Addendum No. 4

January 24, 2018

Renaissance High School Tenant Improvement
West Ada School District
ITB #802601
1307 E Central Drive
Meridian, ID 83642

2 MALL 133 WALL SECTION
A4.20 1/2" = 1'-0"

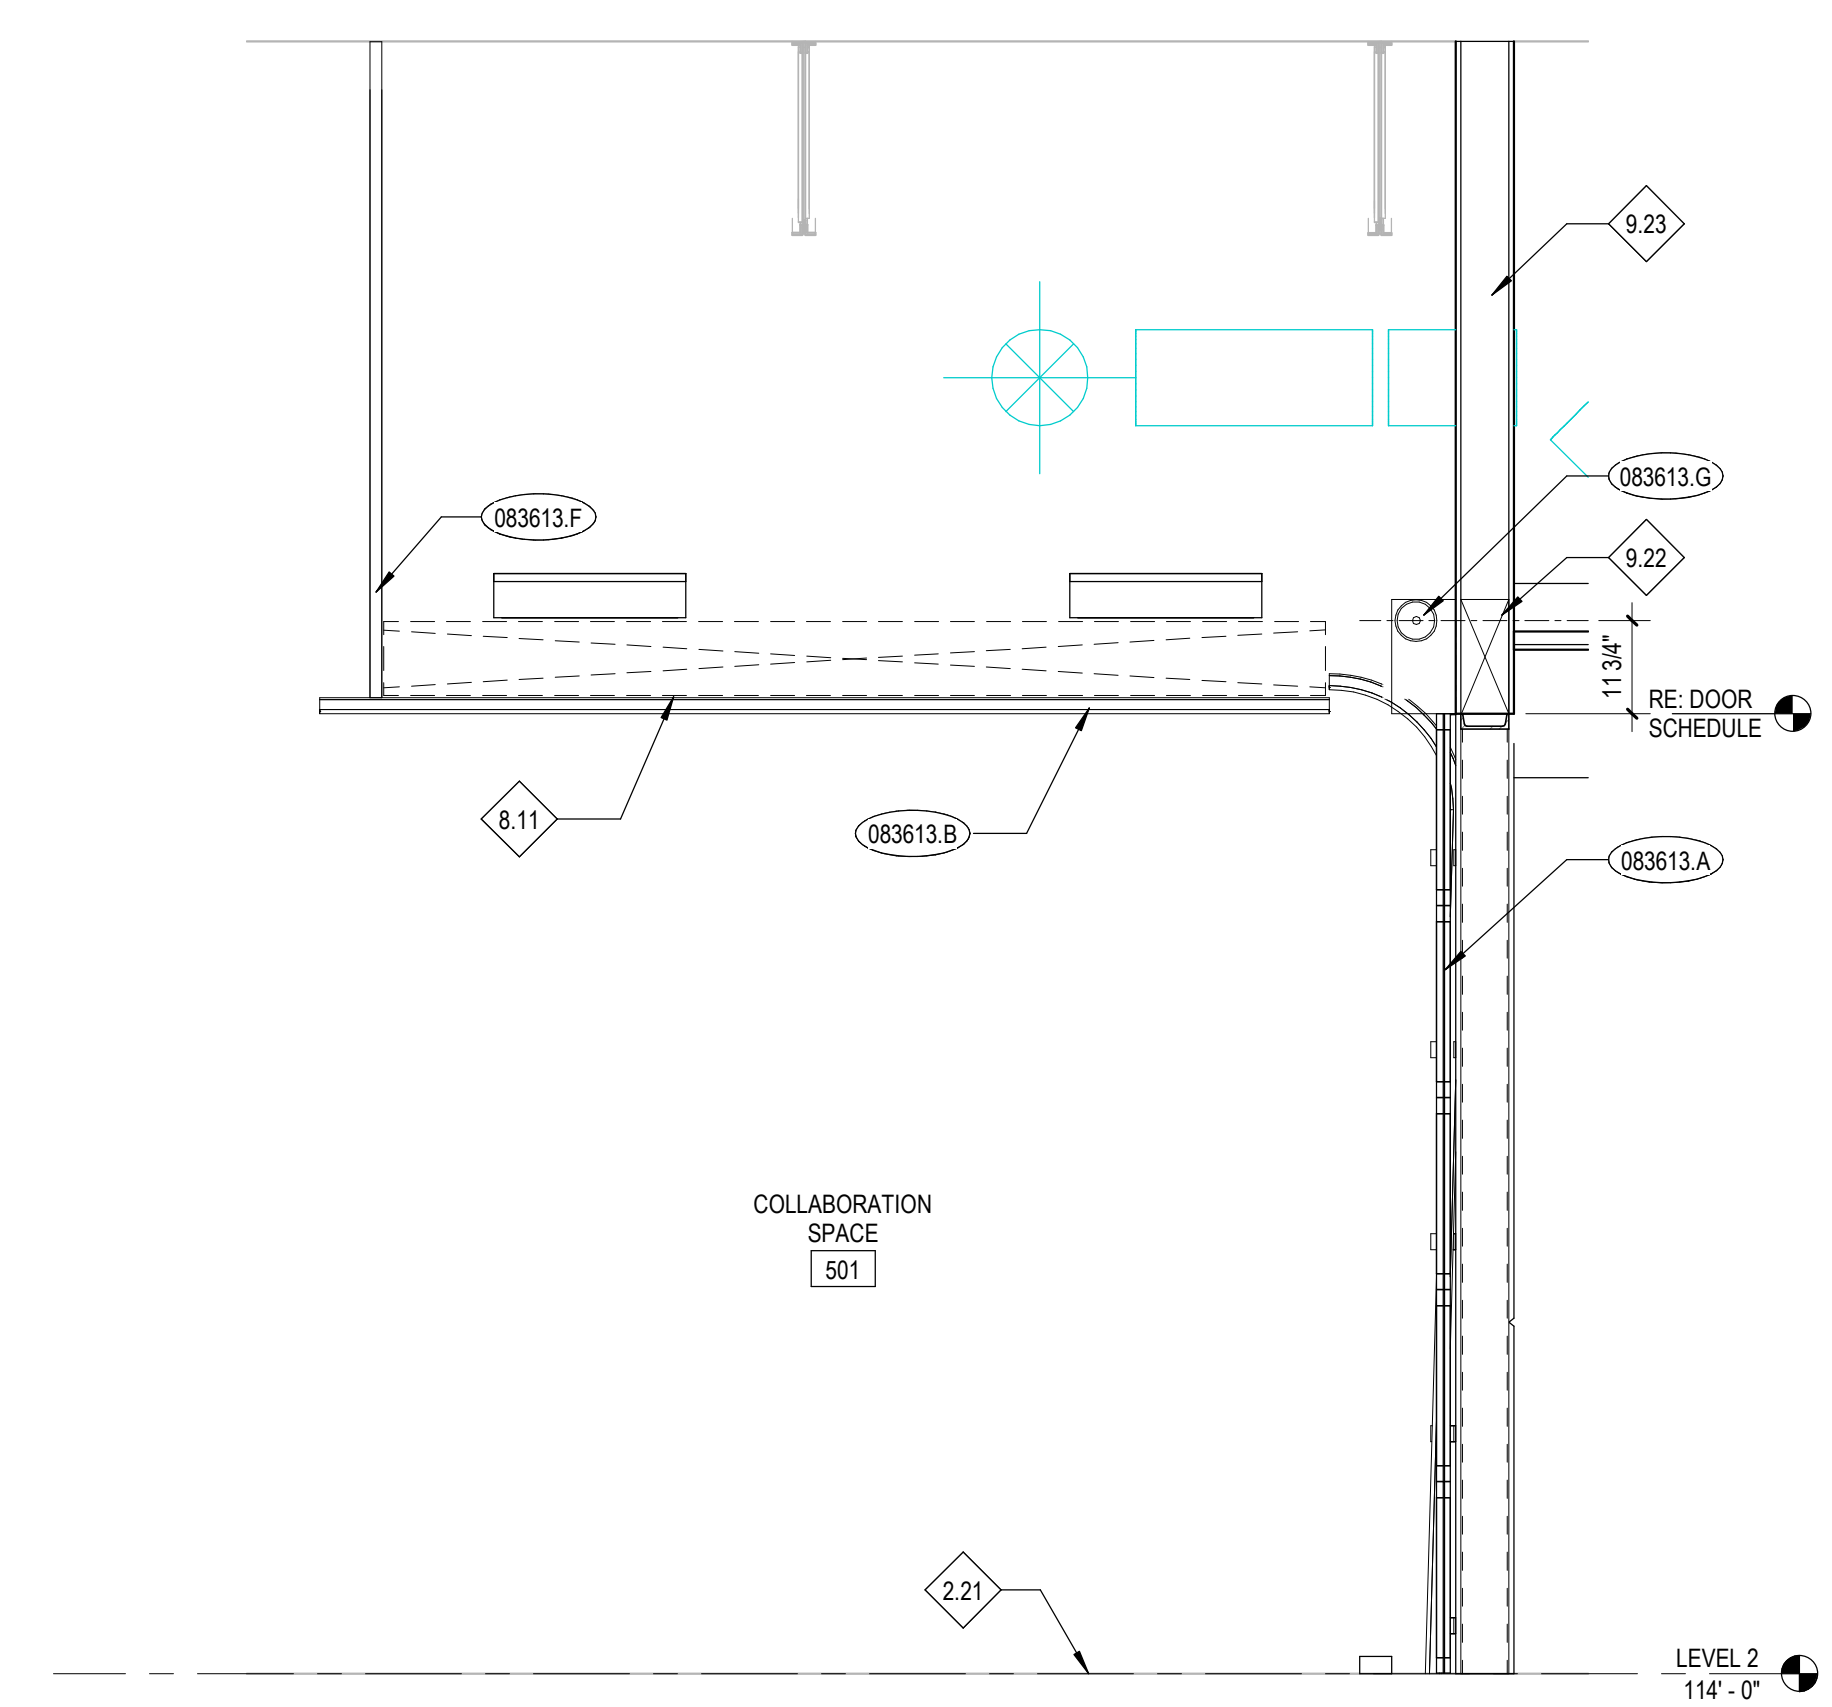
A4.20, attached

Detail 2 revised to include HSS beam at new storefront wall.

2 NEW SLAB DOWEL TO EXISTING SLAB
SCALE: NTS

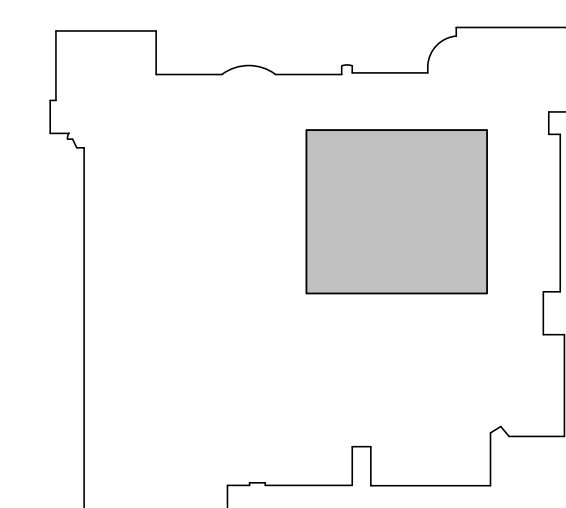
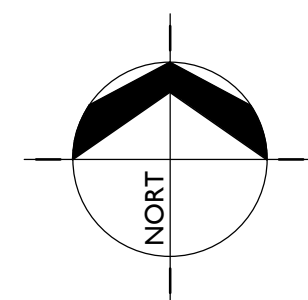
S1.01, attached

Detail 2 New Slab Dowel to Existing Slab, added.

1 LEVEL 2 FRAMING PLAN
 SCALE: 1/8" = 1'-0"

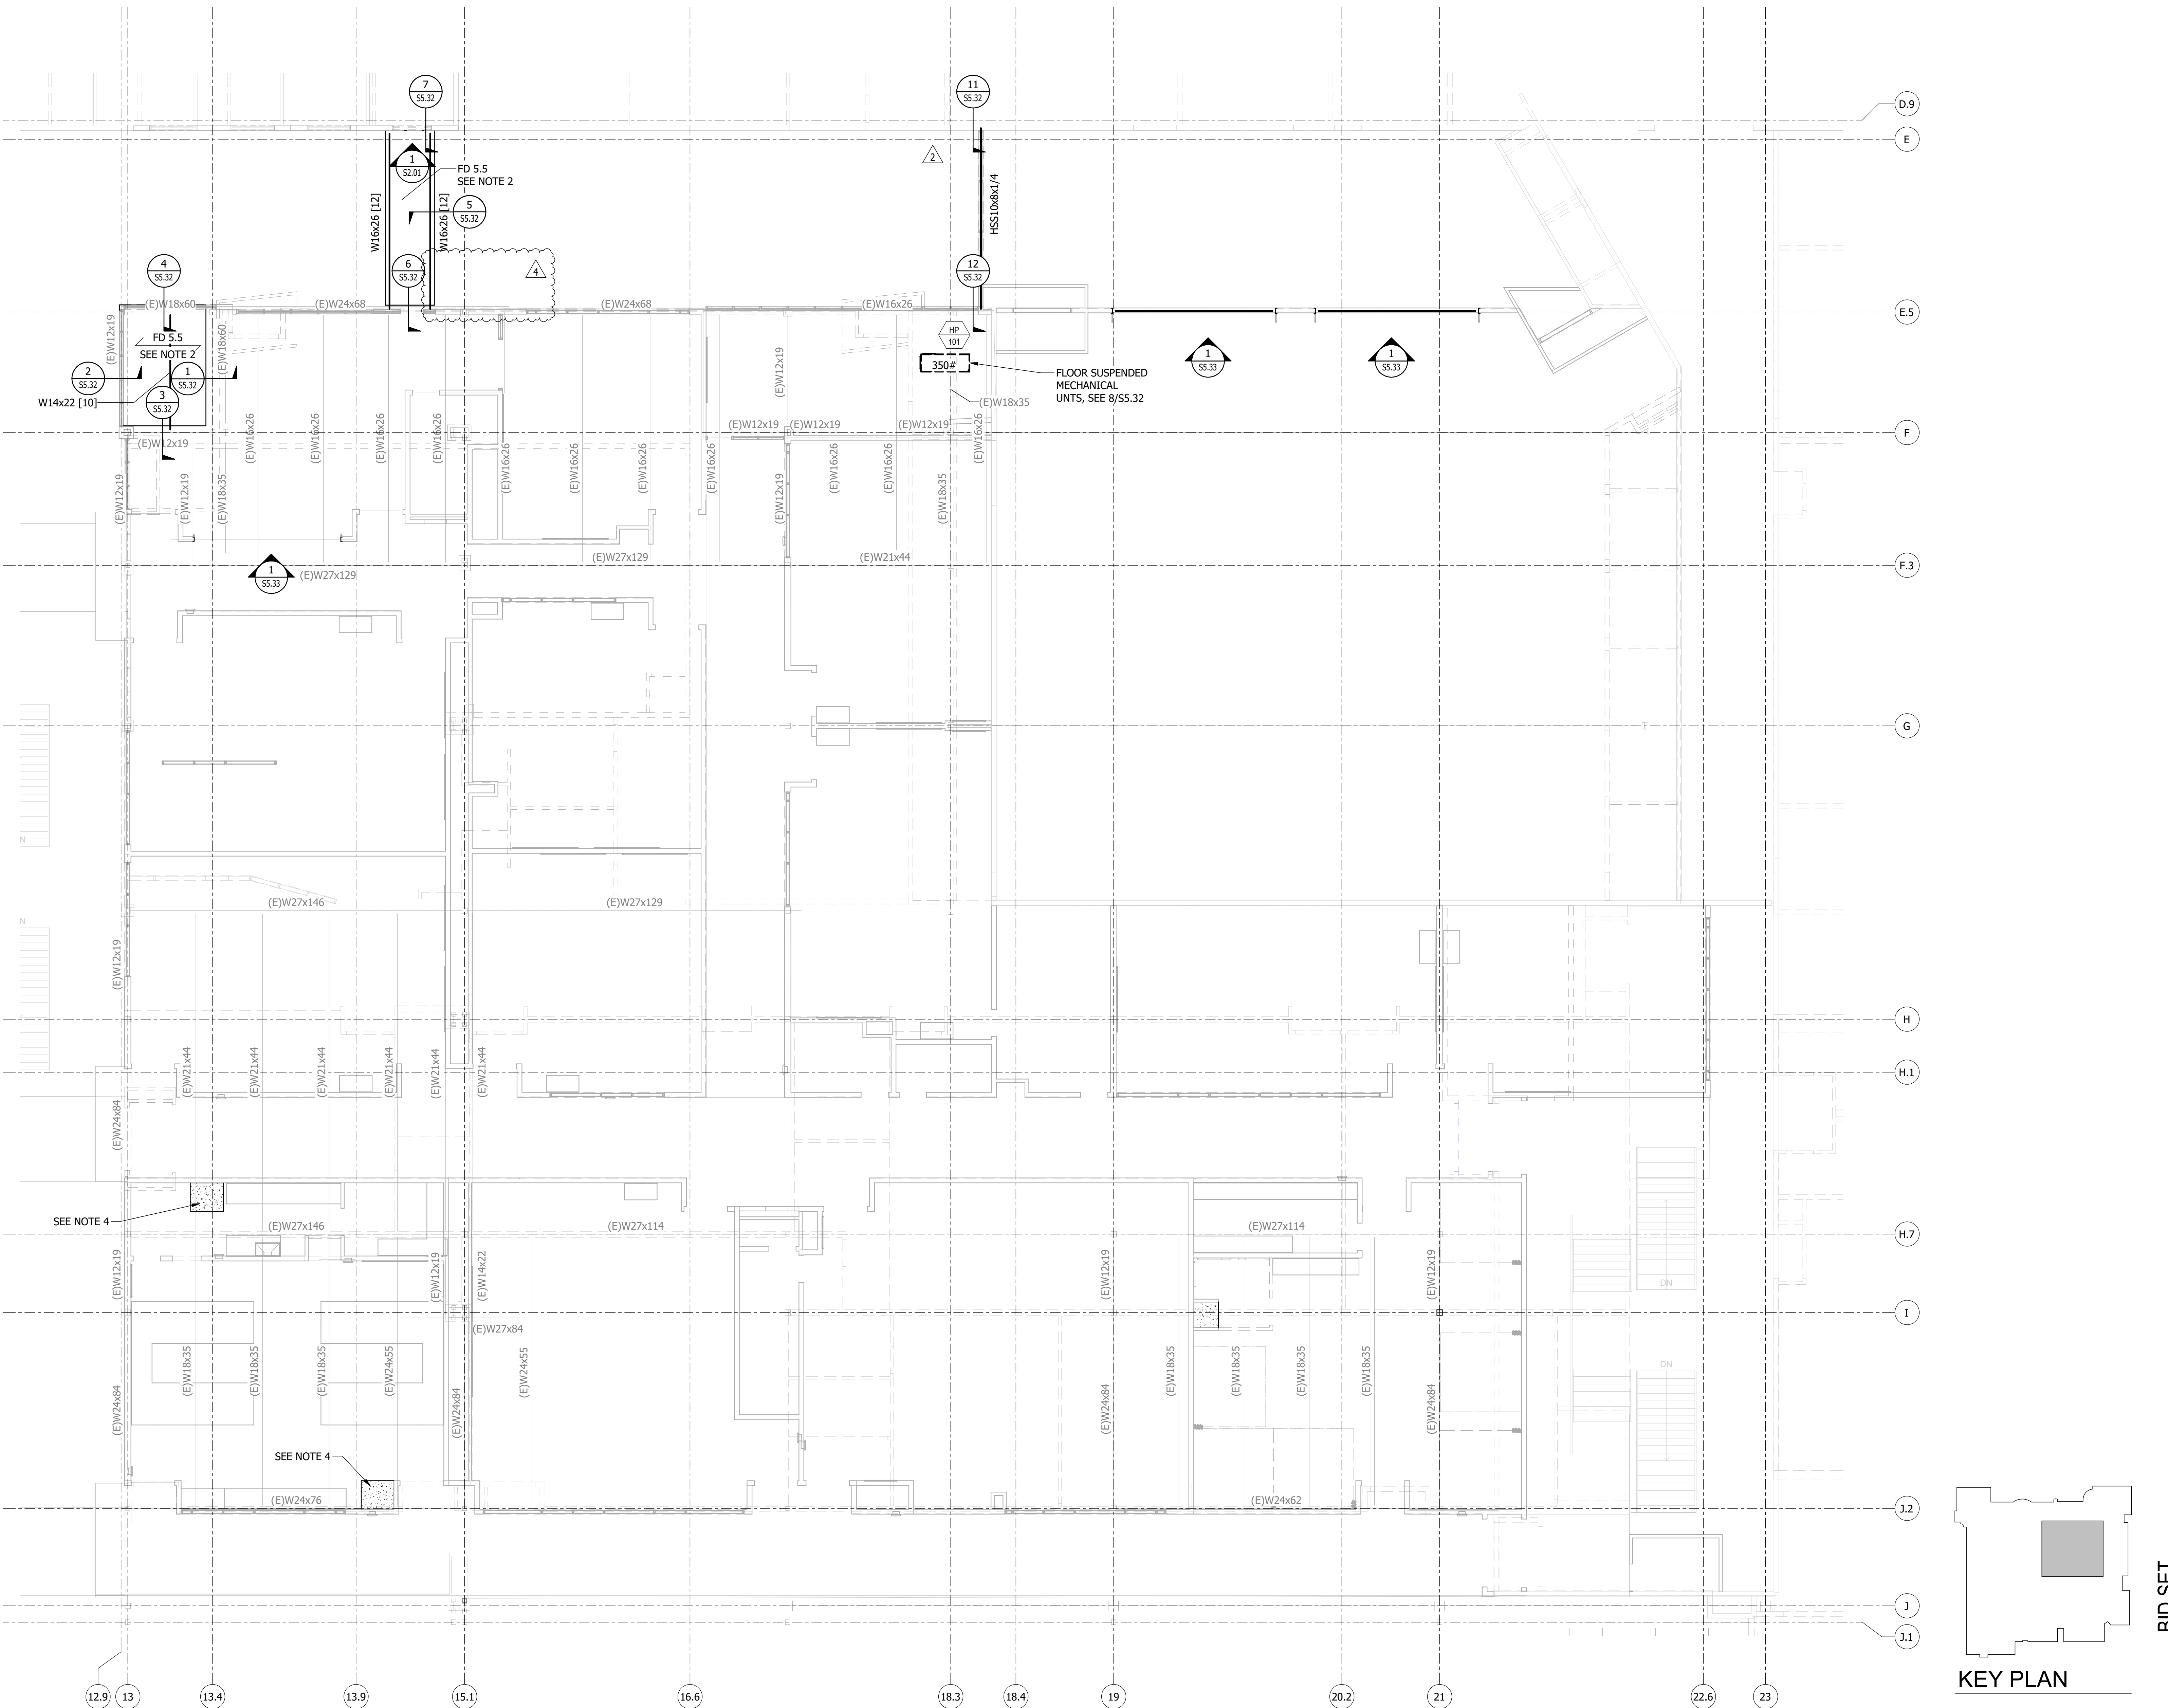
S1.02, attached

Skybridge slab profile revised to match architectural.
